SCHOOL-RELATED CRASH INFRASTRUCTURE REVIEW

MONTGOMERY COUNTY DEPARTMENT OF TRANSPORTATION (MCDOT)

- **Location:** Sligo Avenue at Grove Street
- **Crash Date:** February 5, 2025
- **Crash Time:** Approximately 3:30 PM
- **School Name:** East Silver Spring Elementary School & Takoma Park Middle School
- **School Walkshed Boundary:** Inside
- **Local Case No:** 250005339
- **Review Date:** January 29, 2026

Figure 1 – Sligo Ave at Grove St

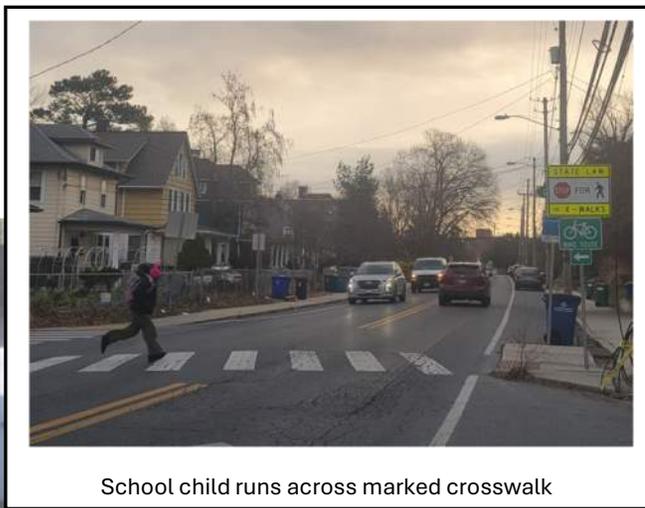
- ☑ **Maintenance:** Replace the existing crosswalk with angled continental crosswalk markings to be parallel with the vehicular approach for the west leg of the subject intersection.
- ☑ **Engineering:** Install centerline hardening along the Sligo Avenue approaches to the Grove Street intersection. This treatment will discourage the crossing of the centerline and visually narrow the travel way. Exposure of vulnerable road users will be reduced by reinforcing the requirement to not cross the centerline.
